**Walton County  
The Grove**

**Change Proposal #3 –  
Monument Sign Scope Removal**

**Change Proposal #3 – Monument Sign Scope Removal**

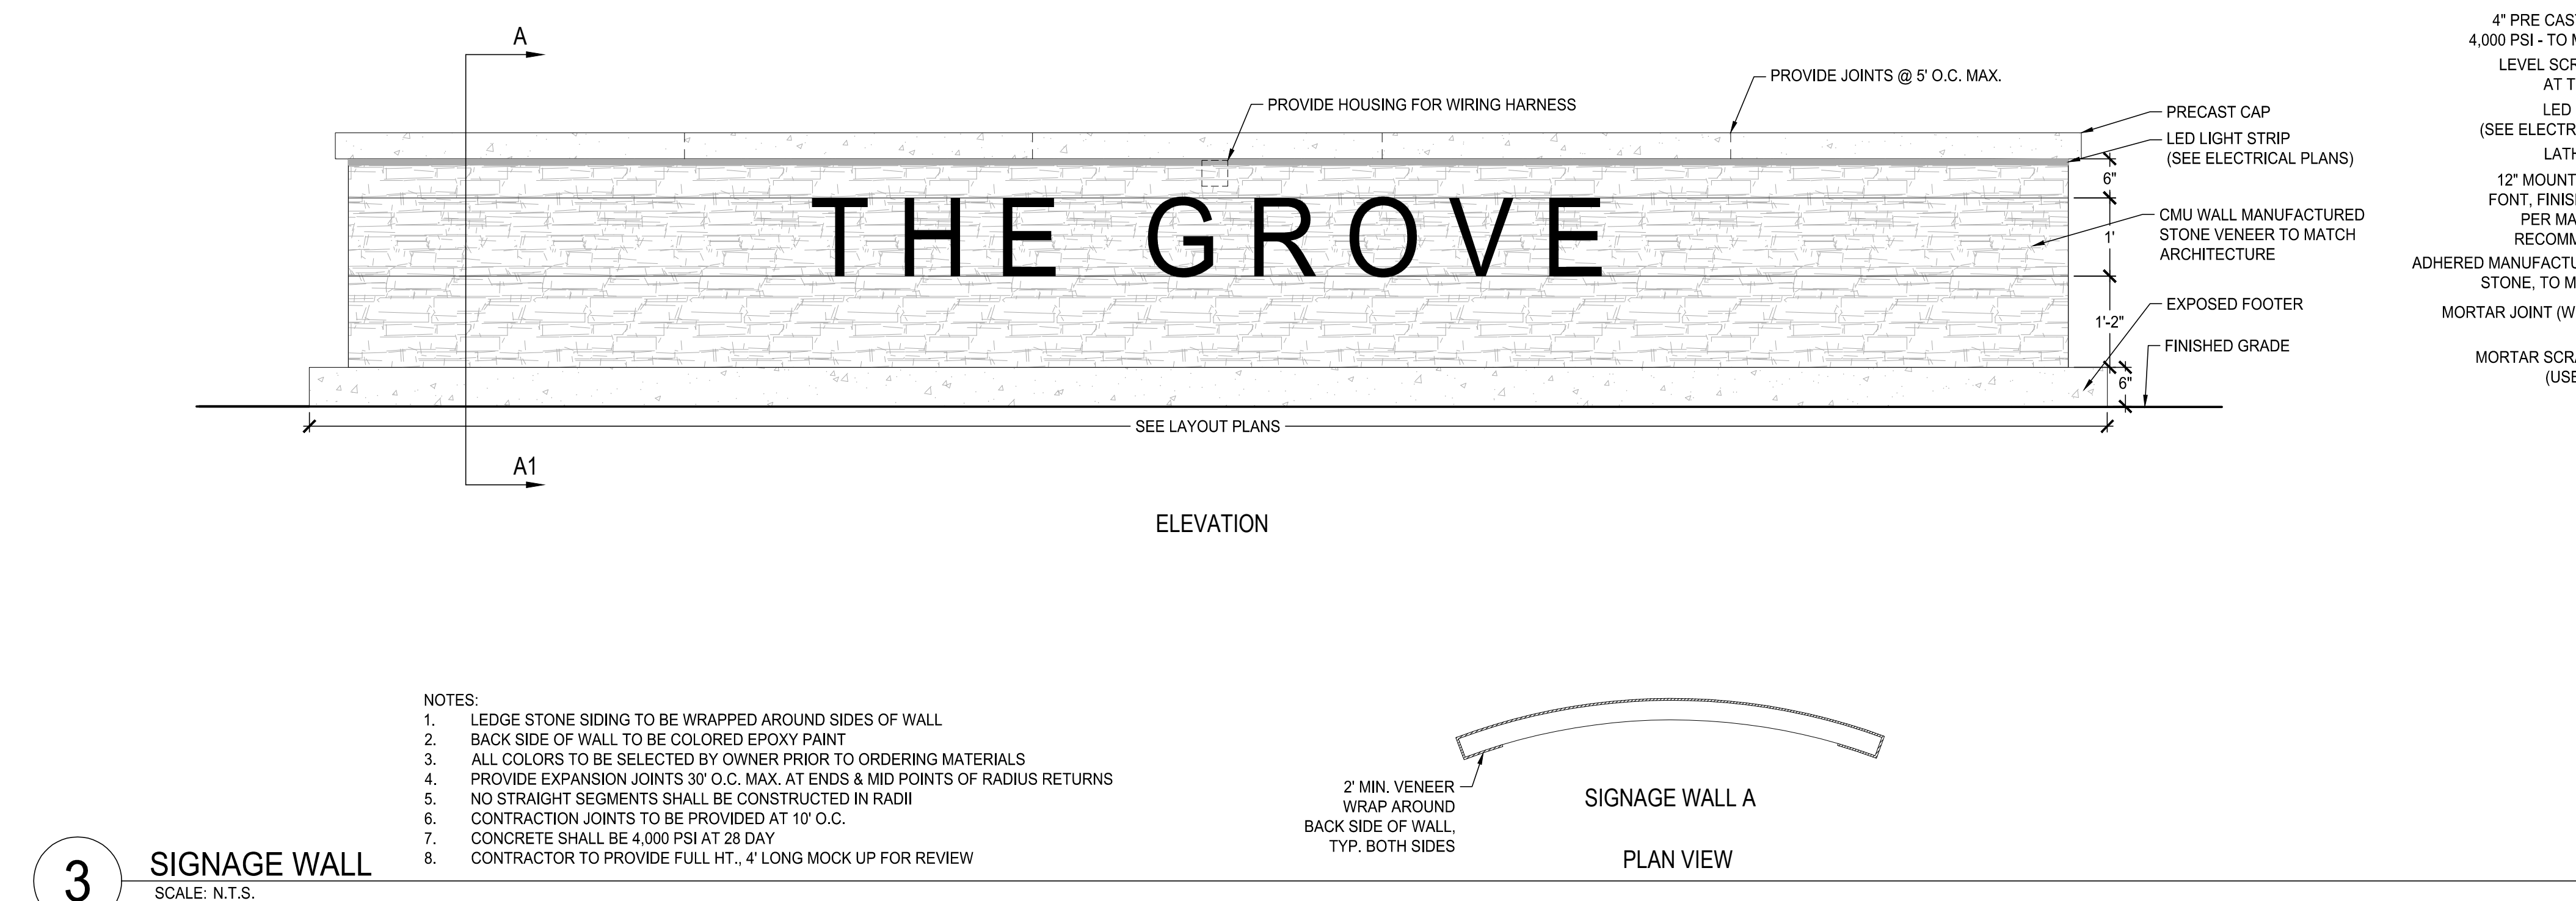
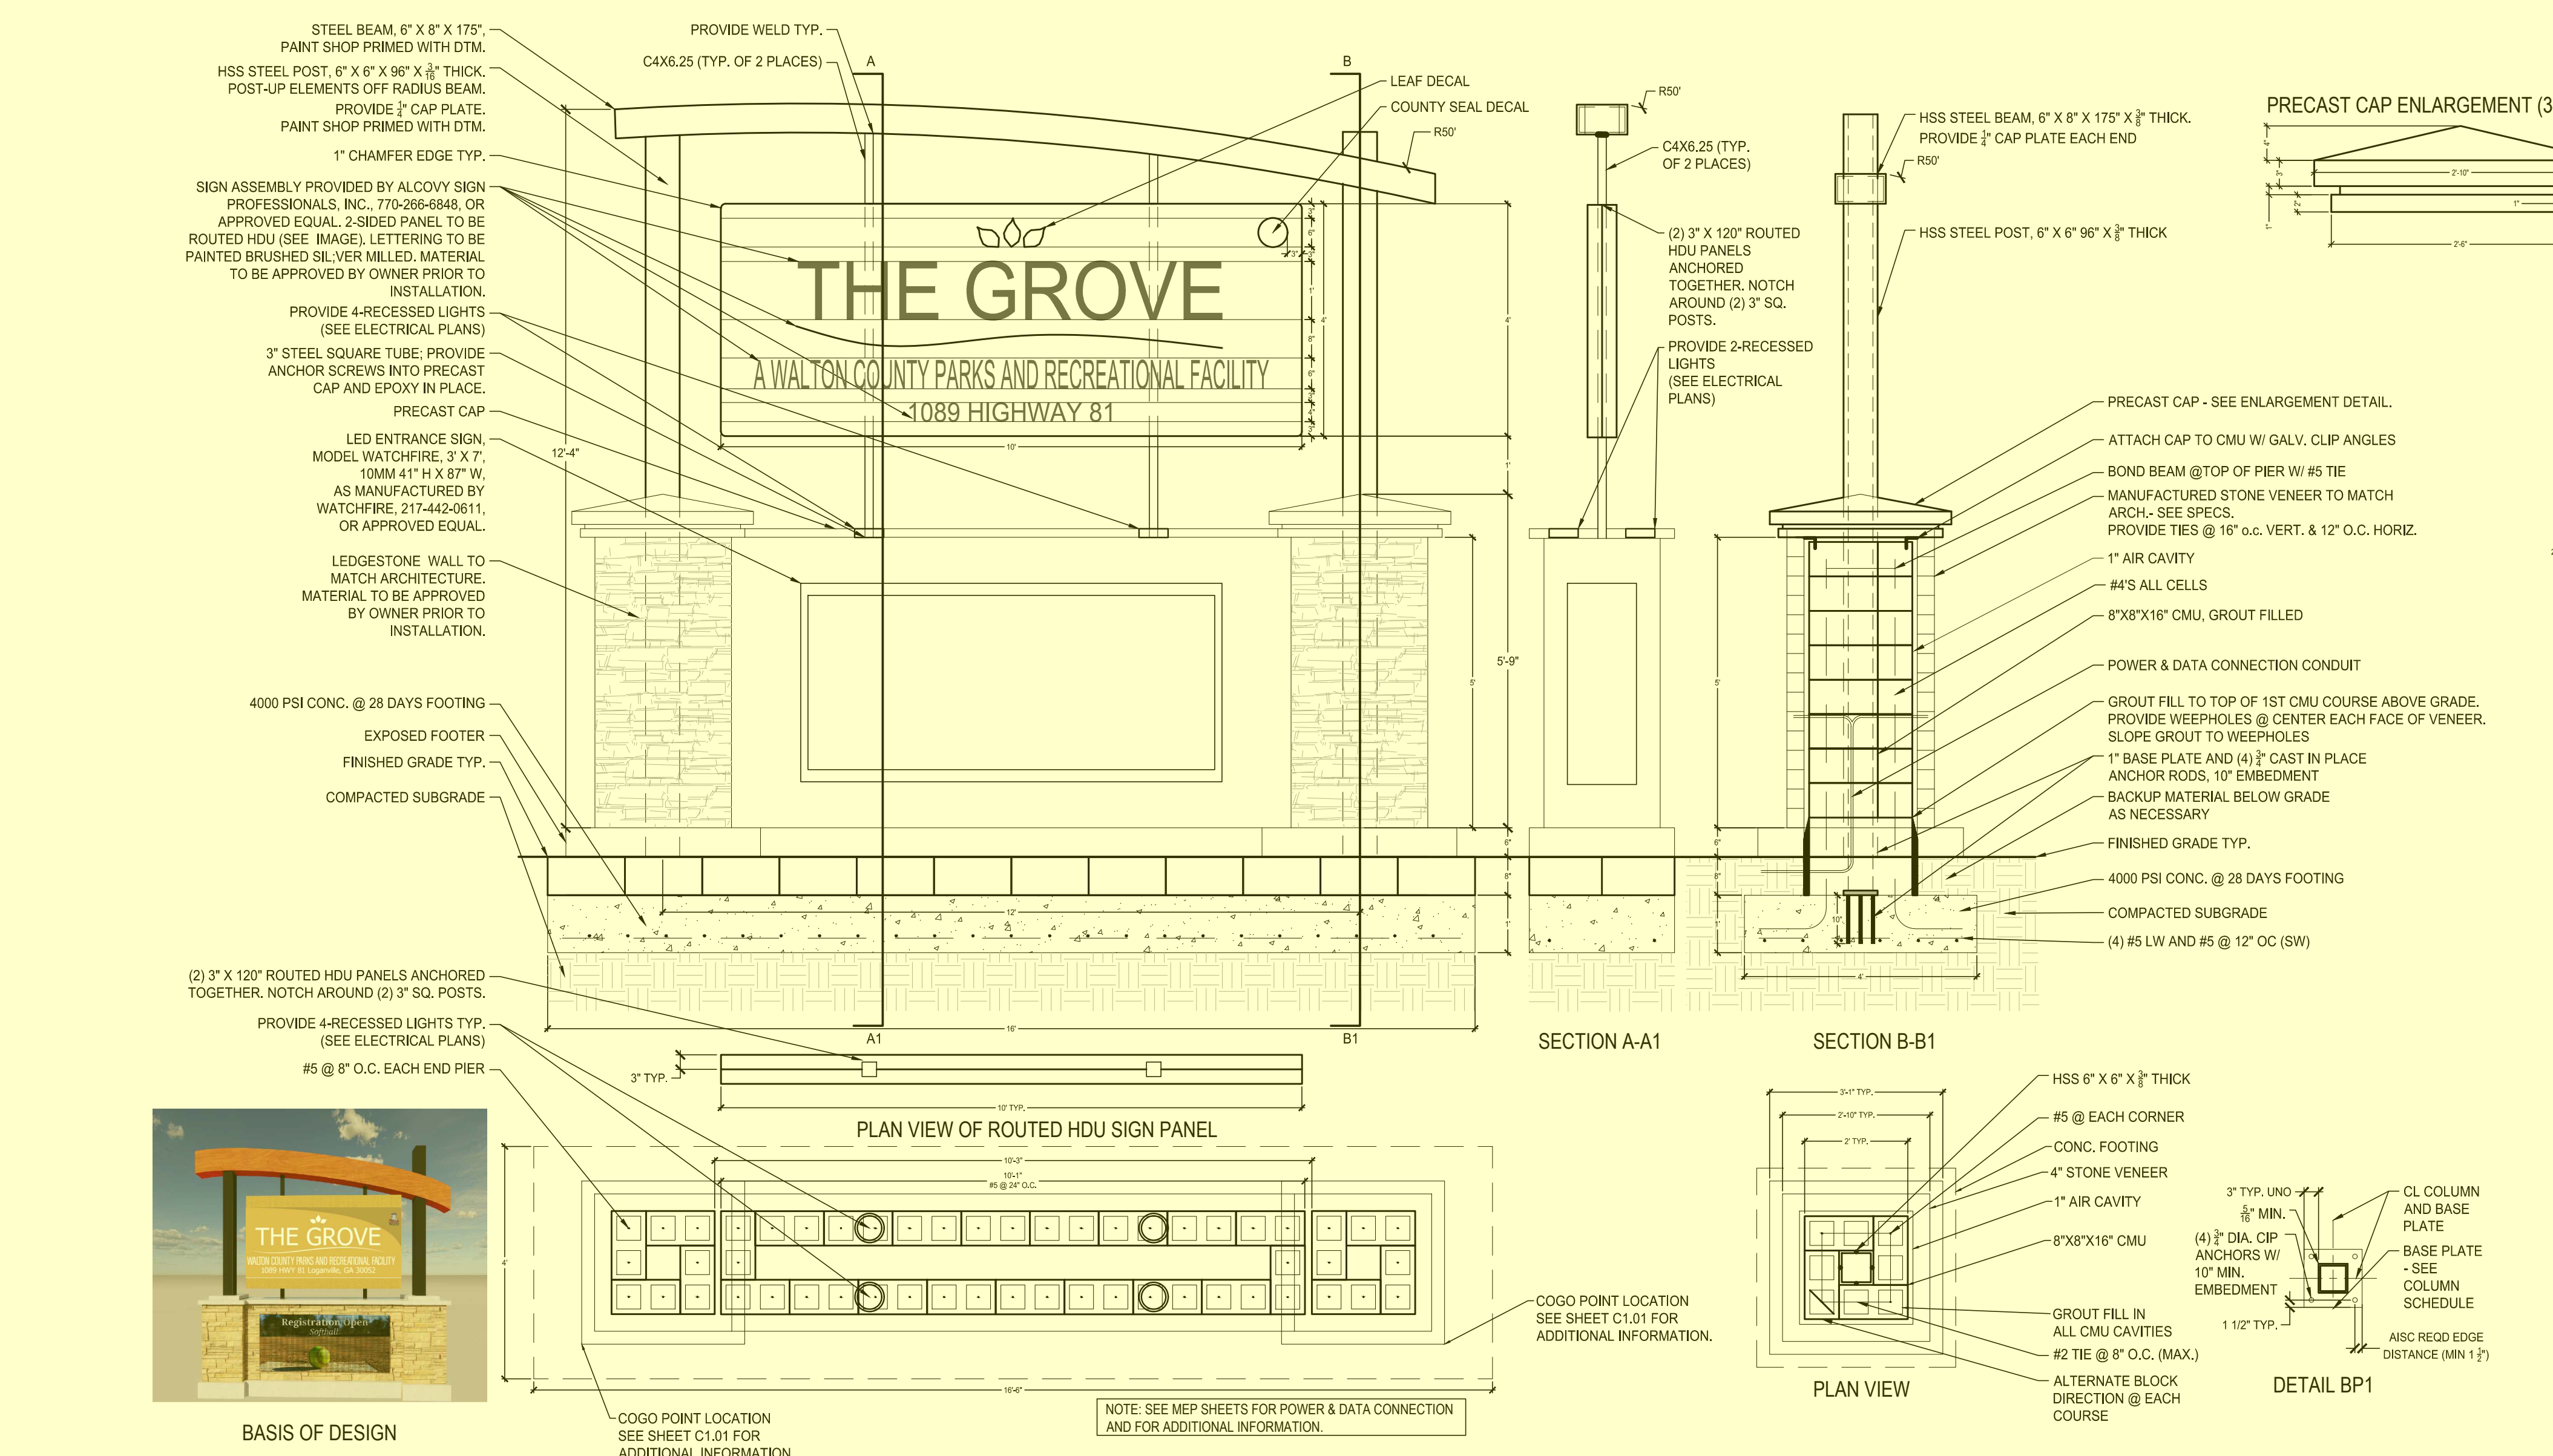
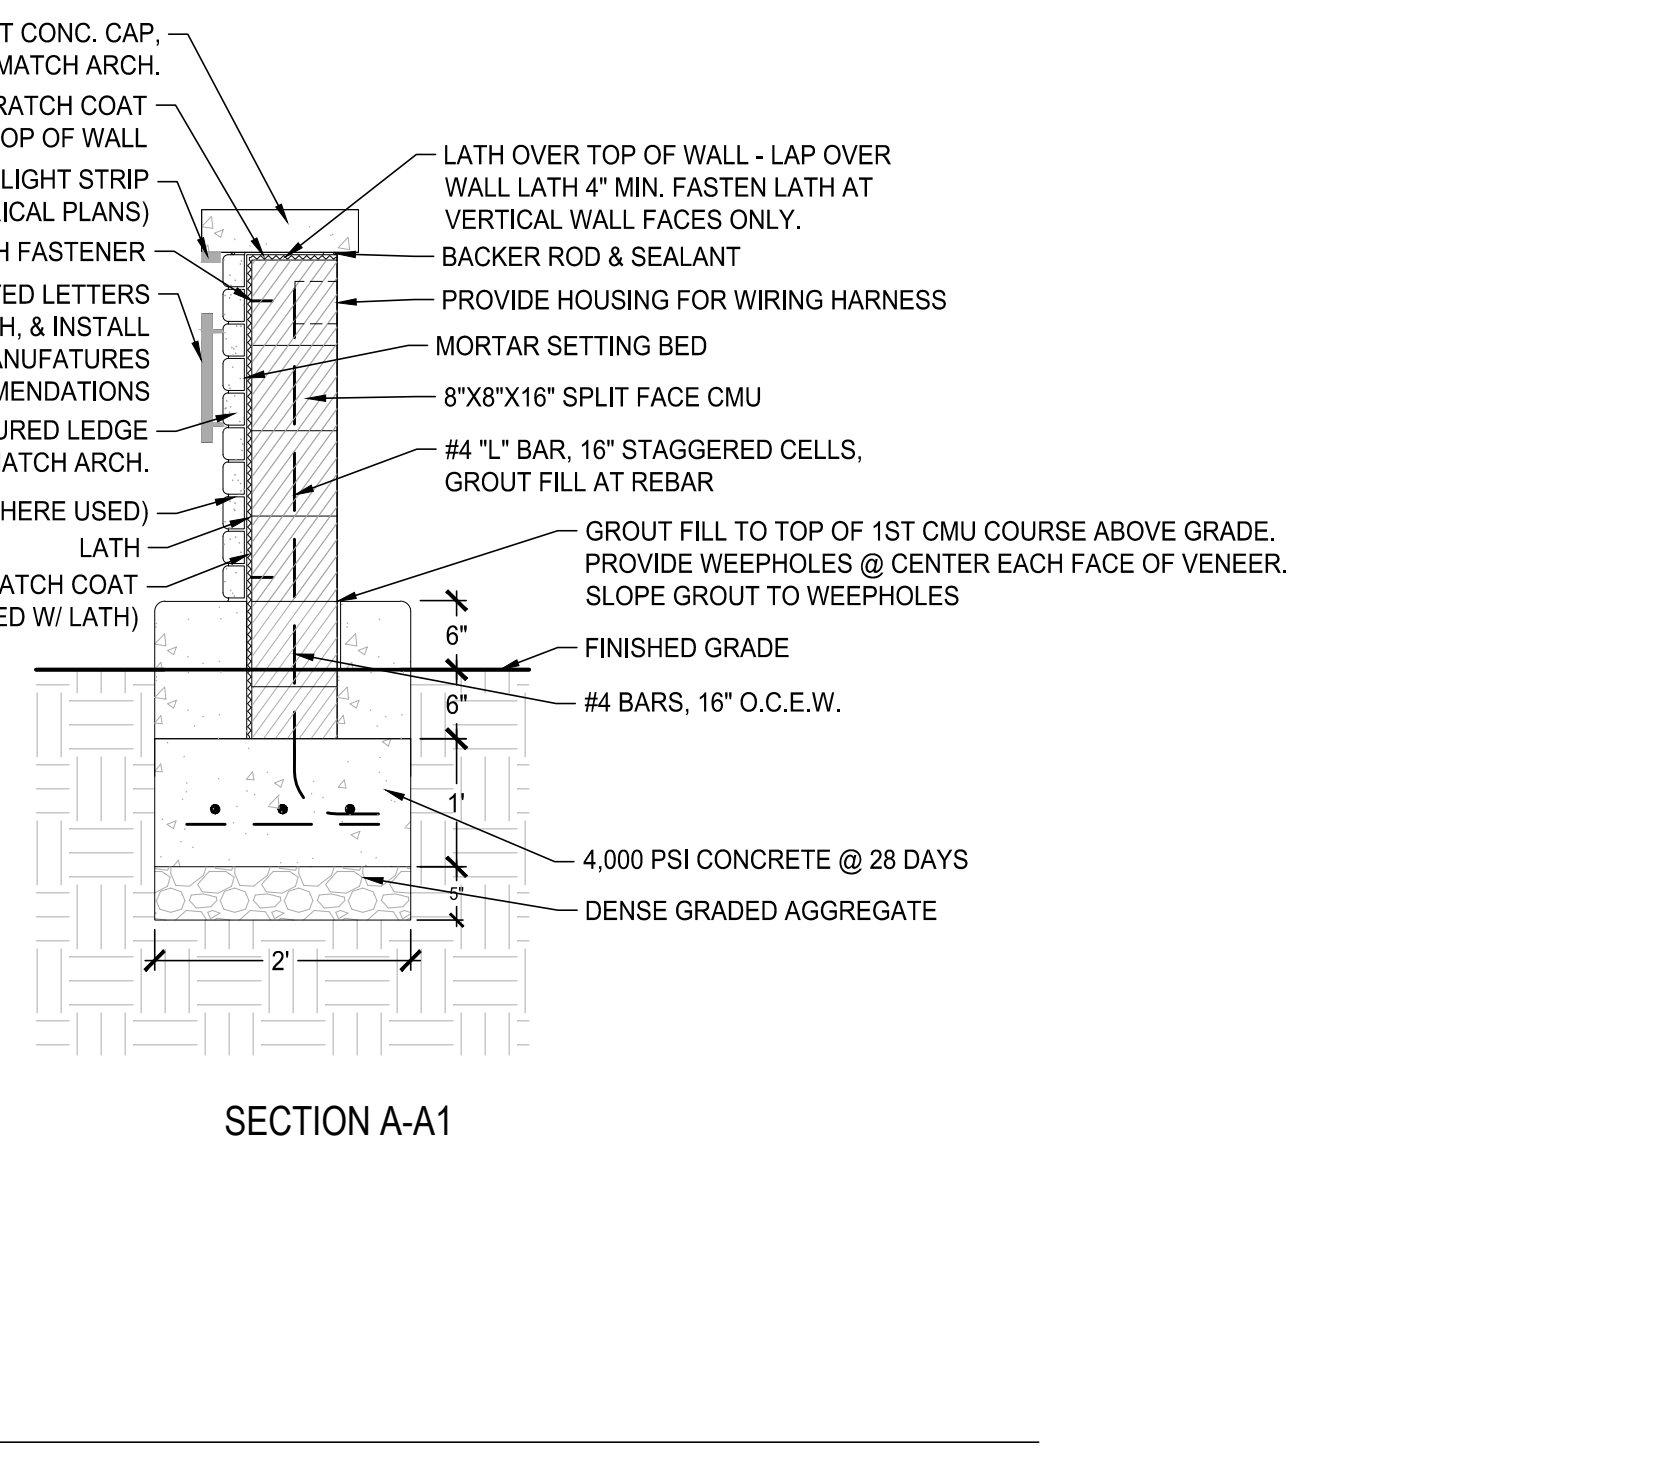
The below change proposal is for the material credit for the monument sign that was removed from RY’s SOW. Please see the breakdown and supporting documentation for your reference.

**DESCRIPTION: REMOVE CONCRETE & MASONRY AT ENTRY SIGN**
